STONYBROOK NEIGHBORHOOD ASSOCIATION

Stonybrook Neighborhood Vision for Washington Street Corridor Development

(Adopted April 11, 2016)

EXHIBIT A

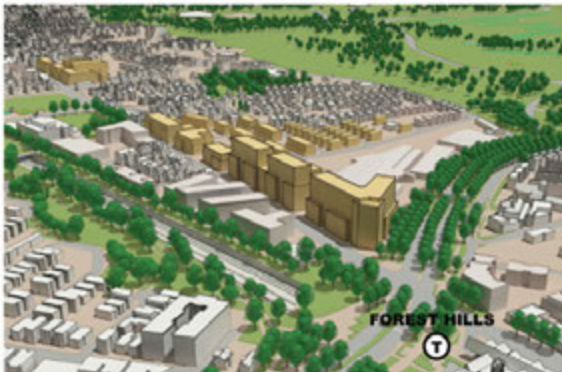
- D. The Plan: JP/Rox Community Workshop #5 on March 5, 2016 presented a development scenario for Forest Hills that included 14-15 story buildings south of Burnett Street on Washington Street, creating a “gateway” to the neighborhood (see Exhibit A):

- 1. Unlike other neighborhood corridors outside the city’s downtown where these building heights exist (e.g. Boylston St. in the Fenway), Washington Street is relatively narrow with only two travel lanes. In this context, buildings this tall, where they occupy substantial portions of the street frontage, have the potential to create a tunnel effect.

- 2. Any consideration or provisions for such heights must be subject to additional meaningful community input and, at a minimum, any allowances for such height more limited, nuanced with respect to massing, and further regulated in such a way that heights in excess of conventional 69’ height are subject to substantial setbacks (e.g. minimum 70’) and street-wall width restrictions at such conventional 69’ height, so as to prevent the creation of an excessively darkened, overwhelming, canyon-like pedestrian environment at street level.

- F.** Workshop #5 specifies that Sites B, C, and D, located on the main commercial street (Washington) should be exclusively residential buildings:
1. In order for dense Transit Oriented Development to be successful, it must balance the need for living space with the need for basic retail and services. All typical daily needs of residents should be accessible within comfortable walking distance to their homes, otherwise the Washington corridor will likely become overwhelmed with resident traffic traveling to and from outlying areas.

- G.** Workshop #5 specifies that Site E, located on smaller residential streets (Rossmore Road, Brookley Road, Stonley Road, and Stedman Street), should be 5-6 story buildings. The resulting height/density combination raises concerns for a few reasons:

1. Existing and proposed abutting/adjacent residential buildings are only three stories.
 2. These smaller residential streets are narrow, and Stedman and Stonley do not have sidewalks. Therefore these four streets are particularly susceptible to the canyon effect and shadows of taller buildings. The negative consequences of 5-6 story buildings abutting or across the street from 3-story residential buildings should be mitigated through liberal incorporation of setbacks, with stepped-up heights only in the new developments closer to Washington Street. The buildings in Sites E should be 3-4 stories between Stonley and Stedman with 5-6 stories (greater heights and massing) only permitted between Stonley and Washington Street.

- H.** Workshop #5 specifies that Site F should contain new three-family housing on Plainfield and Stedman Streets. We support the BRA’s proposal for this residential three-family zone that follows the pattern of existing housing on these streets.
